ADDENDUM #2
Parks and Open Space
Saint Vrain Reach 3 Flood Repair and
Stream Restoration
Phase 2 Project Construction Services
BID# 7144-20

May 21, 2020

STOCKPILE CROSS-SECTION
N.T.S.

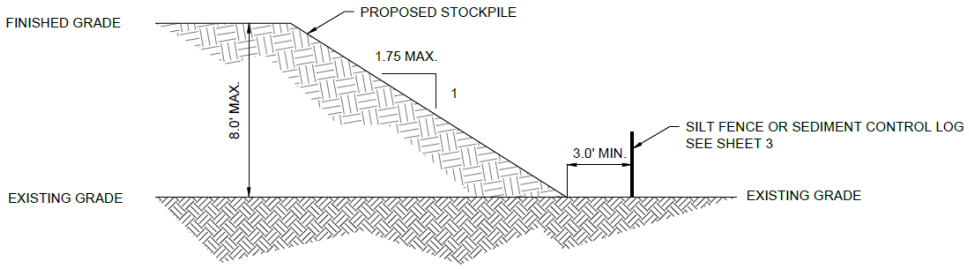
5. Question: Does the contractor have to supply the equipment to stockpile the excess material at 5201 St Vrain Road, Longmont?

Stockpile management that is the Contractor's responsibility is confined to the unloading of the haul trucks and moving soil on-site as needed to achieve the stockpile height range between 4-ft and 8-ft above existing ground (see typical stockpile cross-section below).
